ADDENDUM NO. 03
04 June 2010

Project: **ALLIED HEALTH ADDITION @ CENTRAL CAMPUS**
San Jacinto College District

Bay Project No.: **0822**

ADD-3-SKM2
 0822
 NO SCALE
 06/02/2010
 M3.00

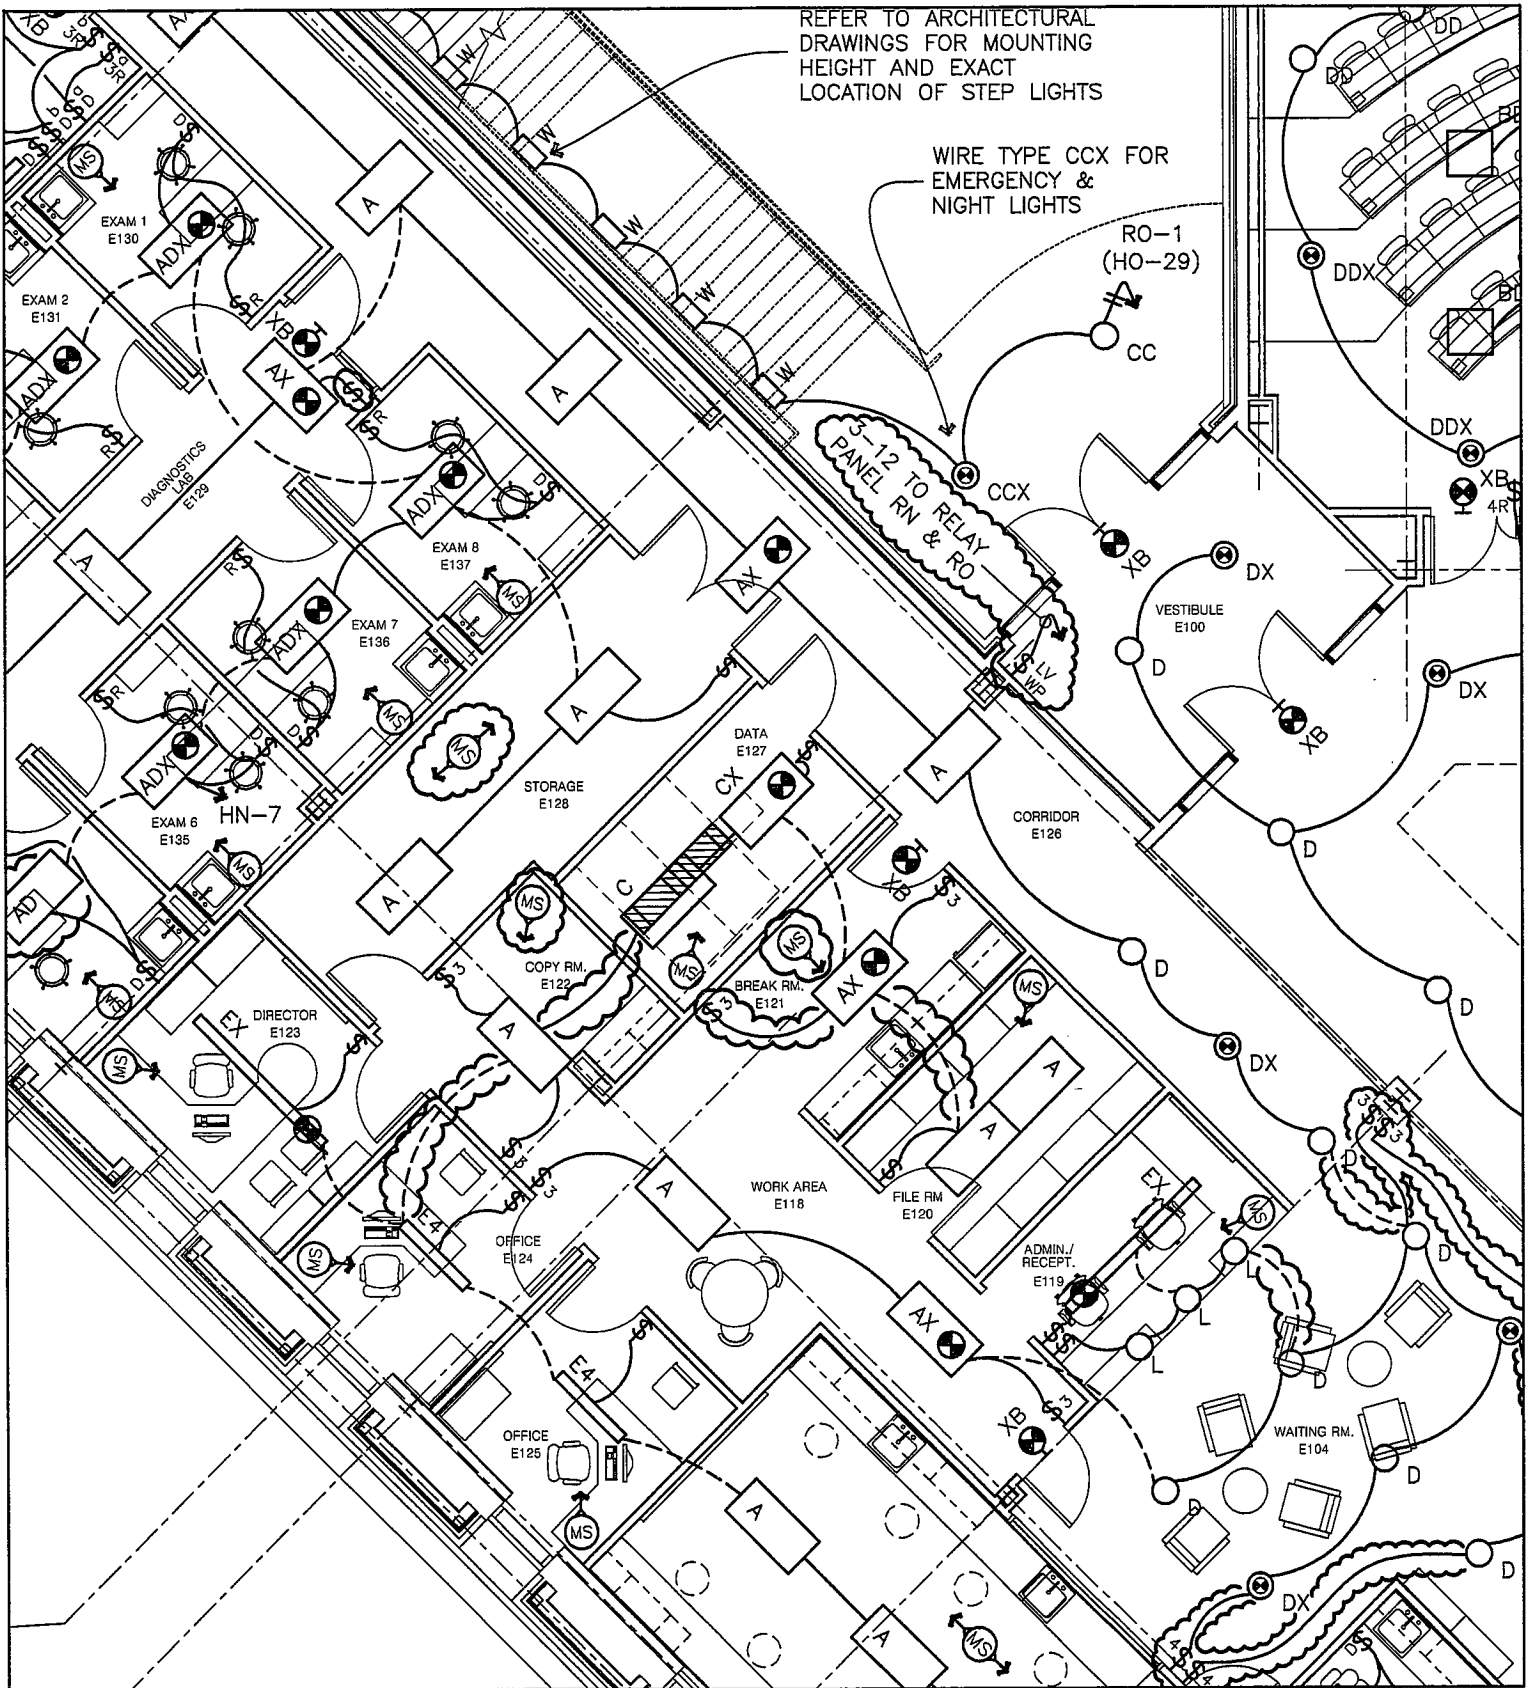
- d. Pump Schedule: Revise pump type to “vertical inline”.
- e. MOTOR STARTER REQUIREMENTS: Revise all FCU’s to have VFD’s.
- f. Revise EXHAUST FAN AND VENT SCHEDULE per the attached drawing ADD-03-SKM2.

REVISED EXHAUST FAN AND VENT SCHEDULE

ADD-03-SKE1

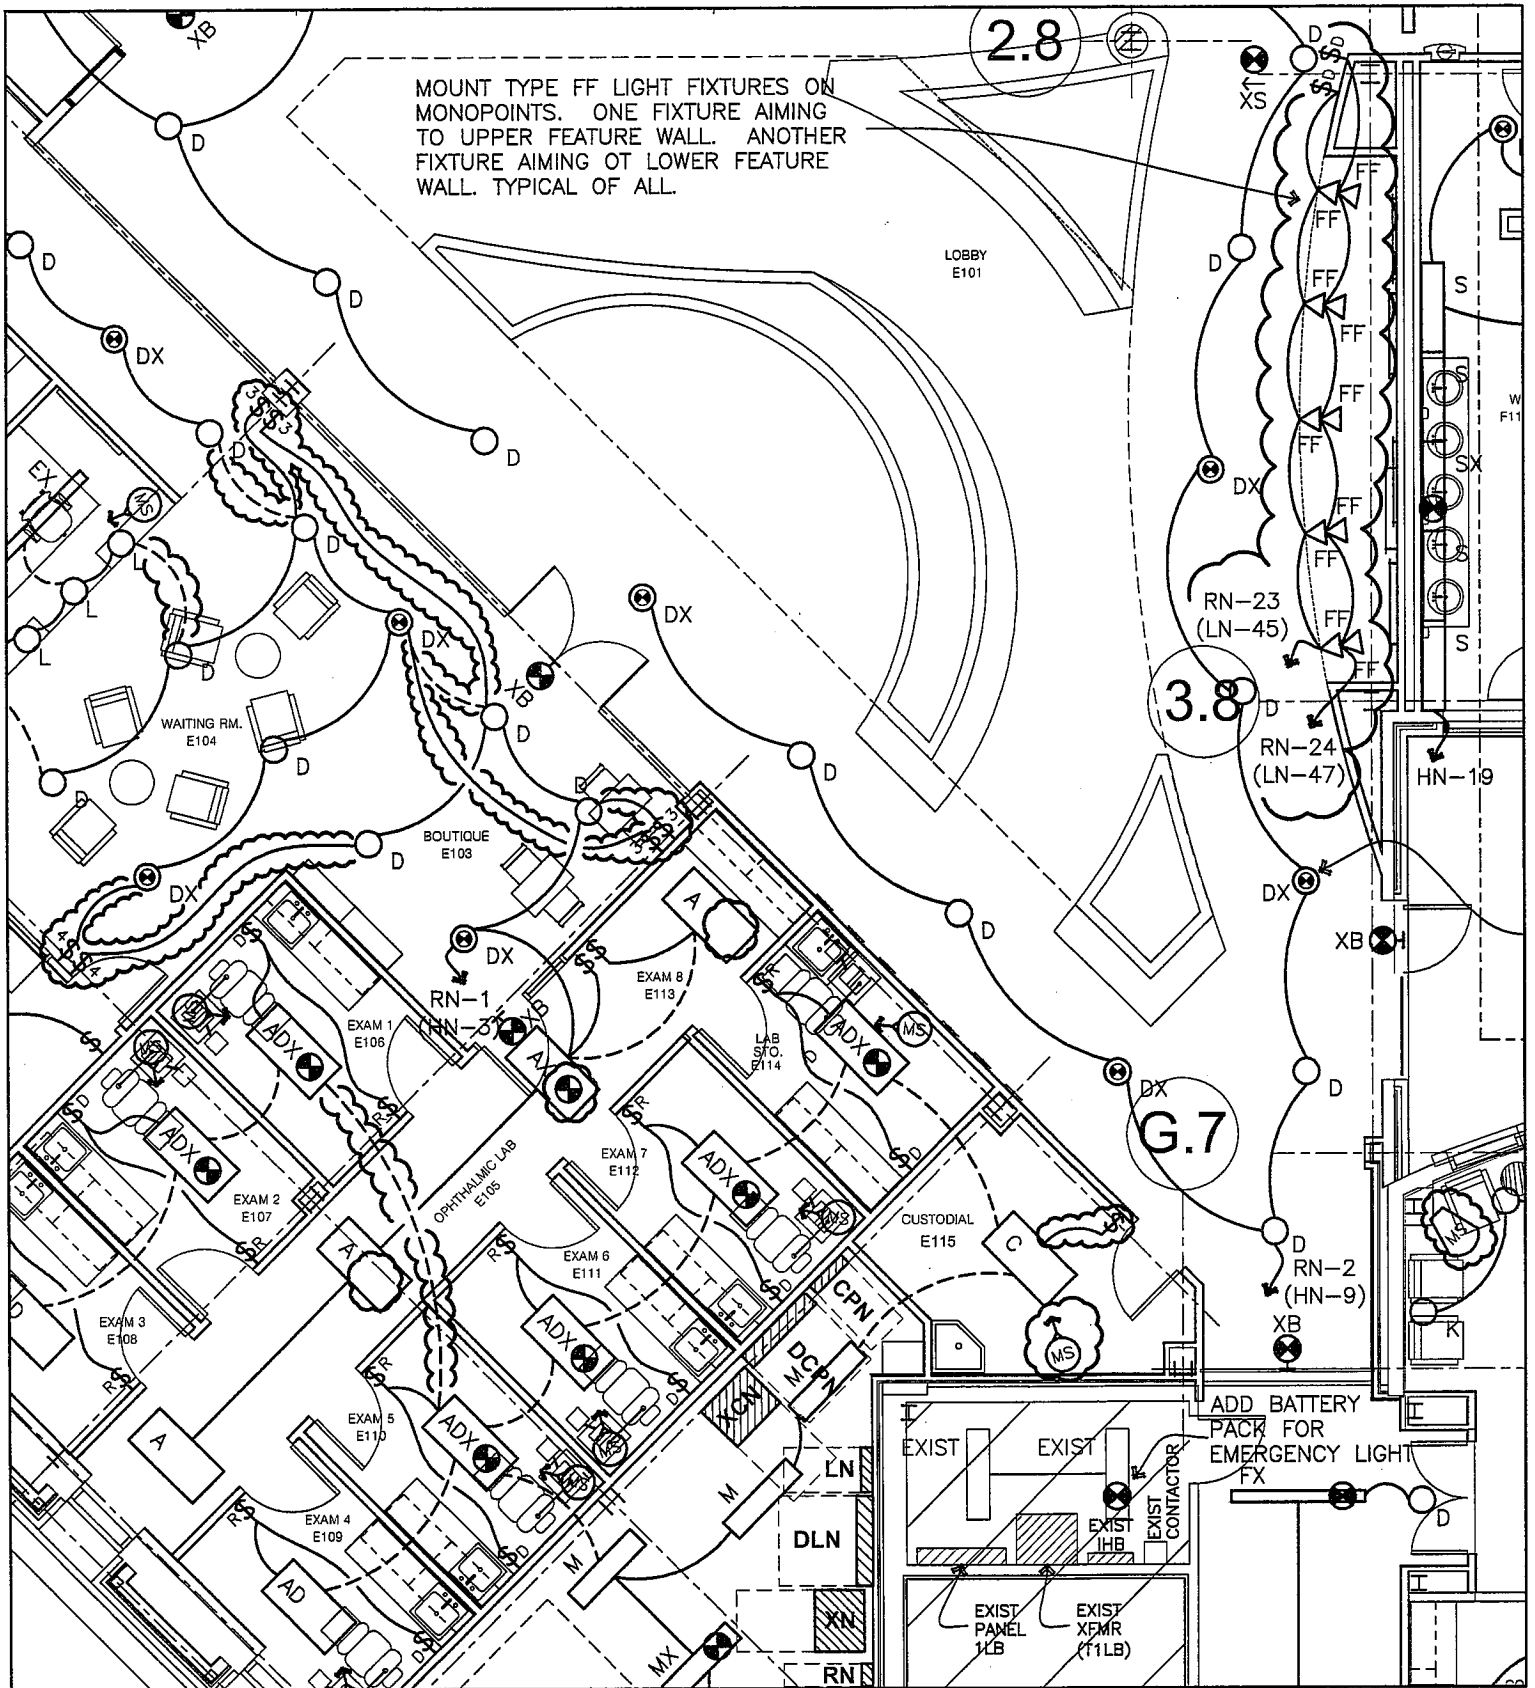
- a. Exam E138 & Exam E134 – Revise light fixture from Type A to Type AD.
- b. Storage E128, Copy RM. E122, Break RM E121 & Workroom E118: See attached Drawing ADD-03-SKE01 for changes.

ADD-03-SKE2

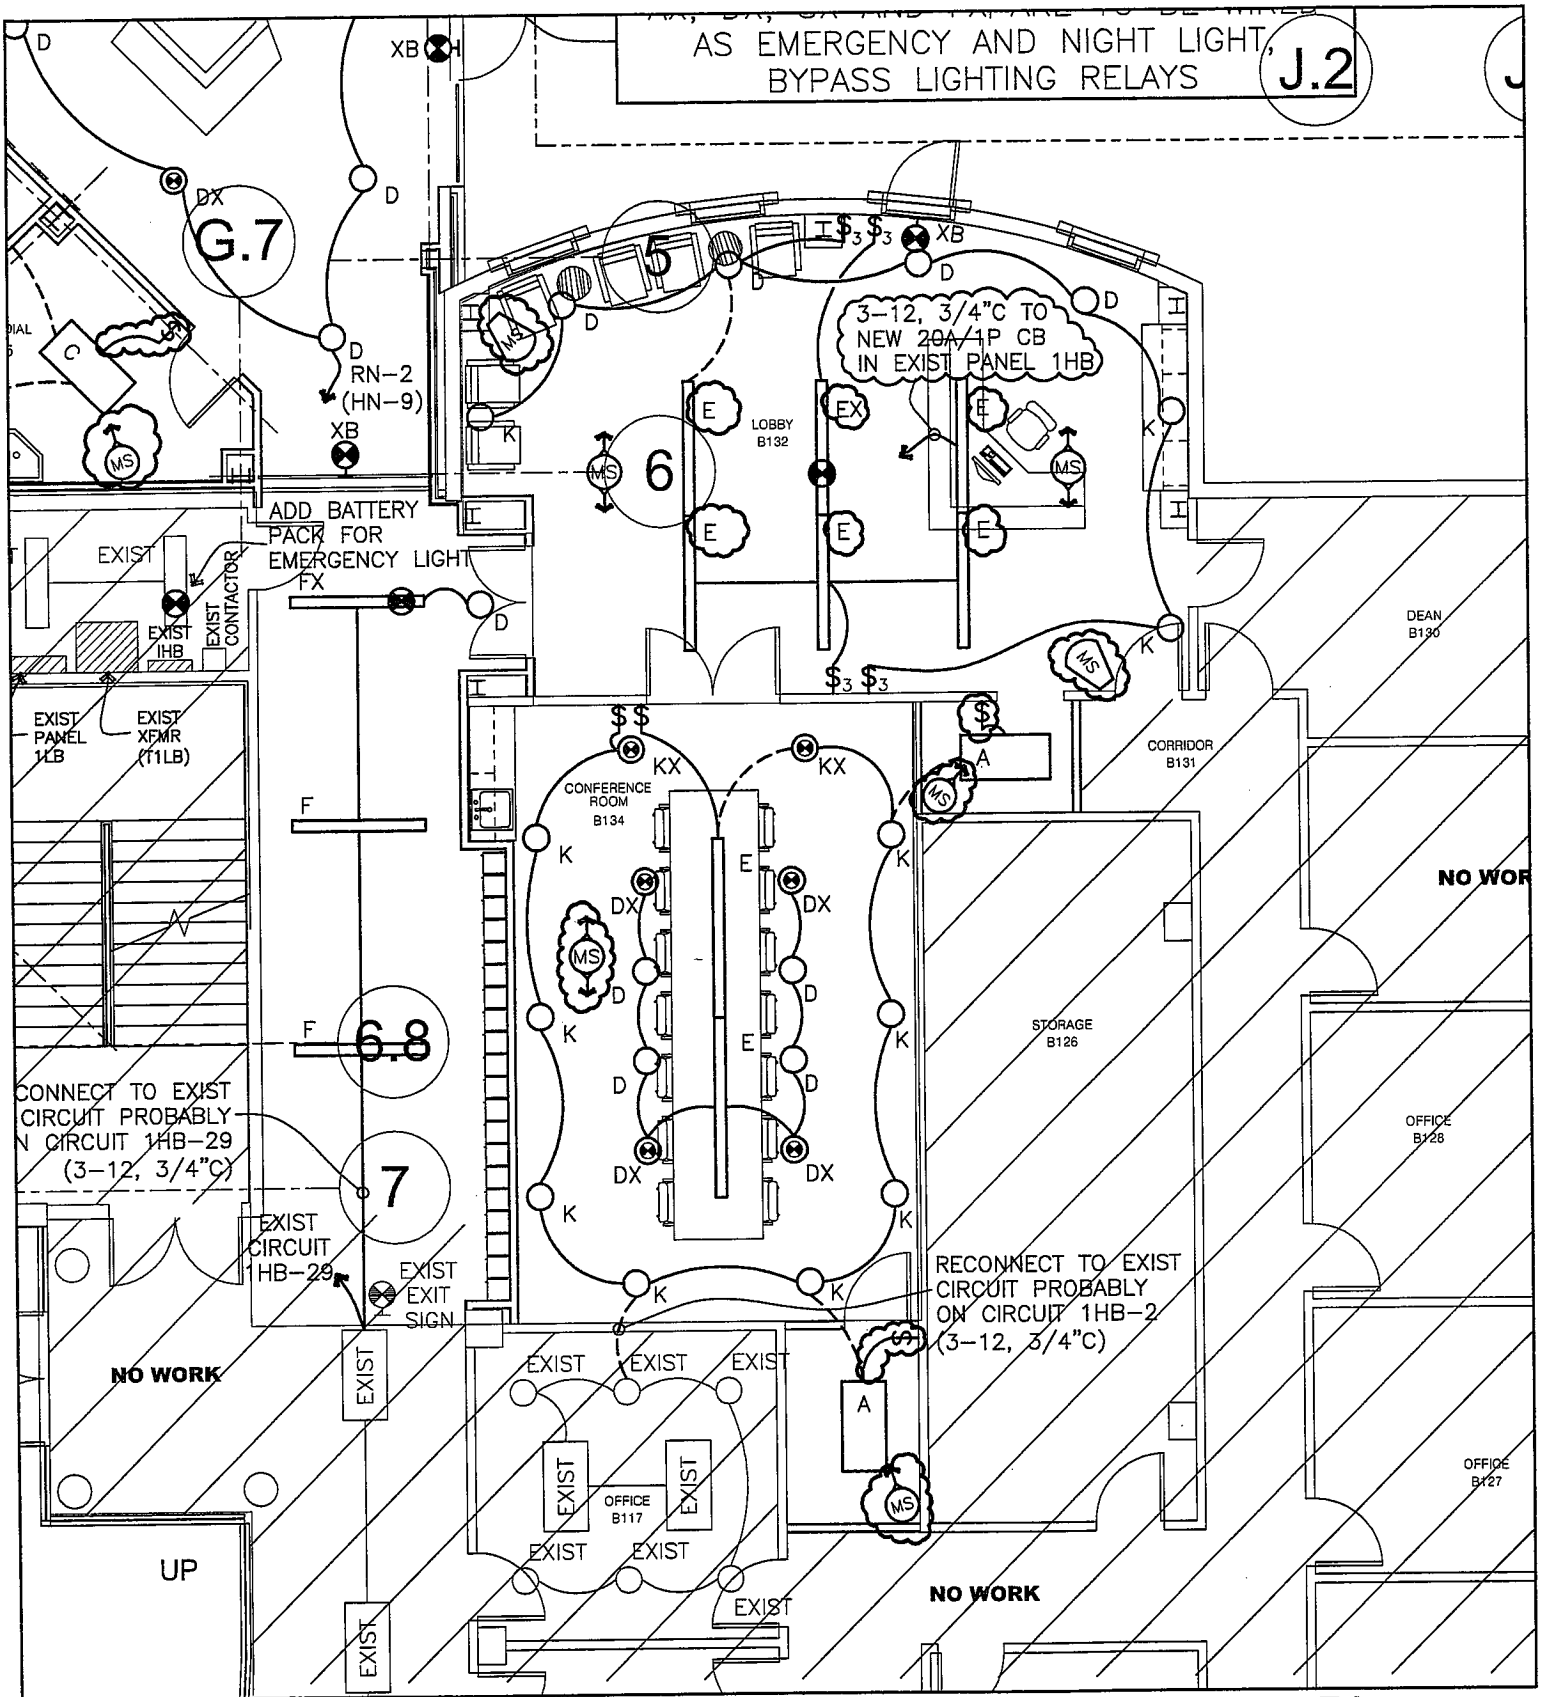
- c. Waiting RM. E104, Exam E106, Custodial E115 and feature wall: See attached Drawing ADD-03-SKE02 for changes.
- d. Lobby B132 & Conference Room B134 – See attached Drawing ADD-03-SKE03 for changes.
